09-001/14 – 2014 MAZDA3 - RATTLE, SNAP, POP OR CRACK NOISE FROM BOTTOM OF A-PILLAR

<b>Subject:</b> RATTLE, SNAP, POP OR CRACK NOISE FROM BOTTOM OF A-PILLAR	<b>Bulletin No:</b> 09-001/14
	<b>Last Issued:</b> 08/01/2014

- This bulletin supersedes the previous bulletin 09-001/14, issued on 01/08/14 and 03/28/14. The APPLICABLE MODEL(S)/VINS, REPAIR PROCEDURE, and WARRANTY INFORMATION have been revised.
- Changes are noted below in Red beside the change bar.

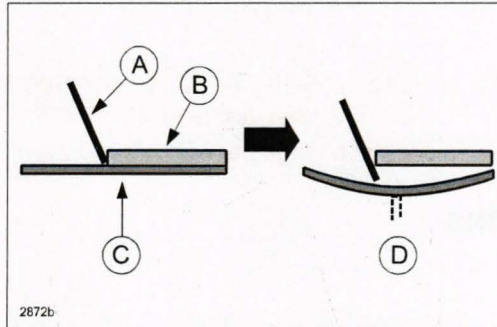
- Place the tip of a covered\* flat-blade screwdriver (A) between the wiper bracket (B) and the dash upper panel/cowl upper plate (C) and hit the head of the screwdriver with a hammer to create a clearance of approximately 0.5 mm (D) between the two.

**\*NOTE:** To avoid damage to the paint, wrap protective tape around the tip of the screwdriver. If the panels are scratched, apply appropriate corrosion protection primer.

Locations to create clearance

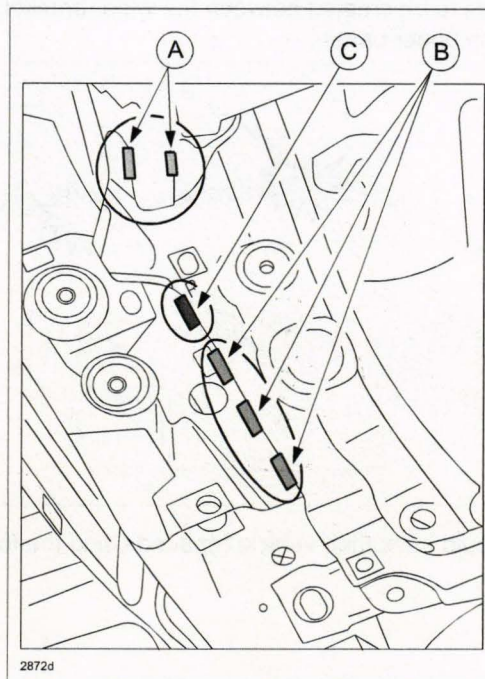
- Areas A and B: Create a clearance for all vehicles
- Area C: Create a clearance for vehicles with VIN range JM1BM\*\*\*\*\*100001 - 189735

**Area A for all vehicles**

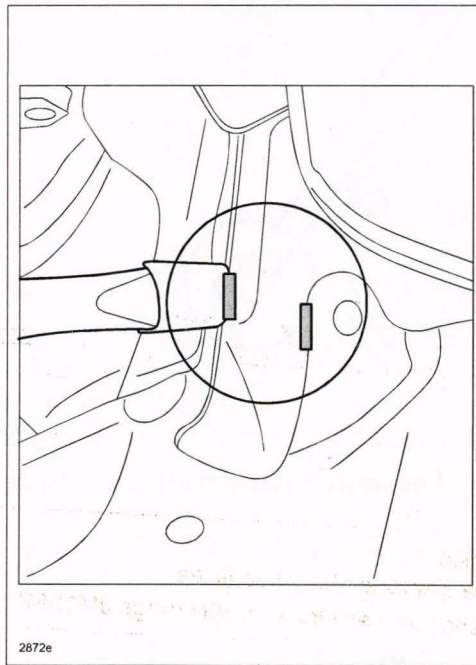
5. Apply a body adhesive to Area A between the wiper bracket and the dash upper panel (at the two locations shown).
